**IAMGOLD RESPONSE TO  
MATTAGAMI FIRST NATION'S INFORMATION REQUESTS**

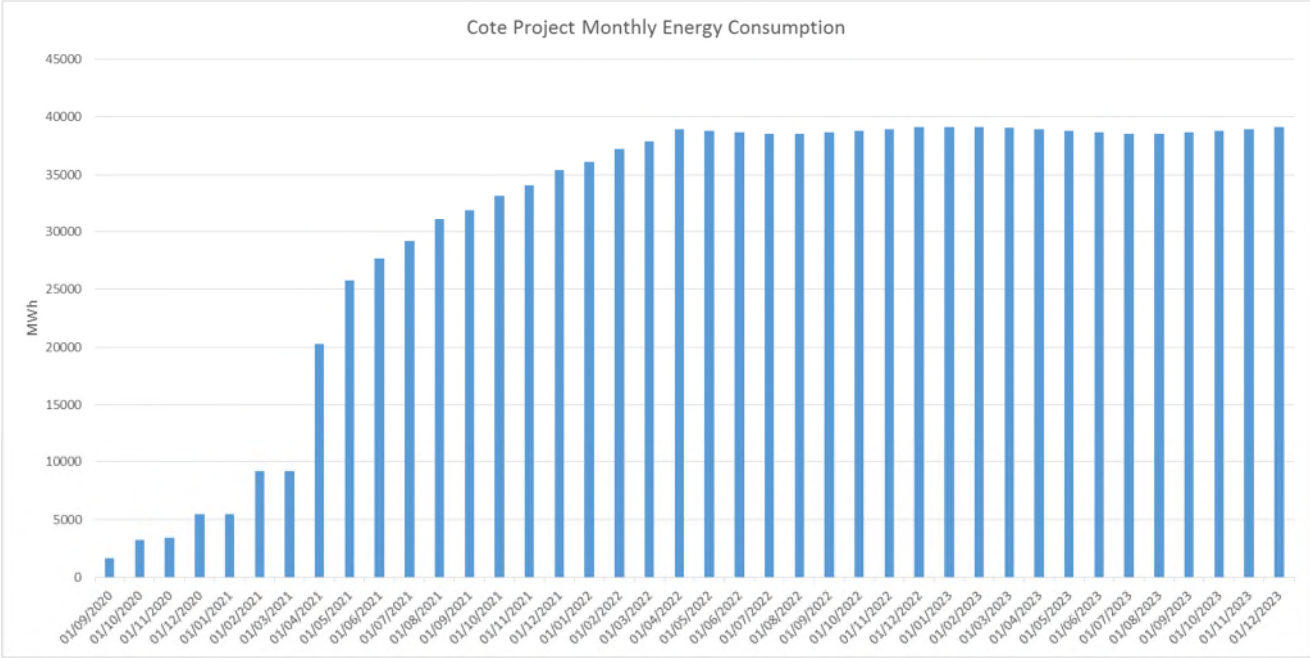
a) Please provide typical hourly load curves for summer and winter (i.e. hourly consumption expectations during the summer months and winter months).

a) A graph showing the load build-up for the Mine is provided below. The majority of the load (approximately 94%) will be process and mining load. The process and mining loads will remain constant year round as the Mine will be a 24hr/day, 365 days/year operation. The heating for the Project will be propane fuelled, so there will not be much variation in the HVAC load year round.
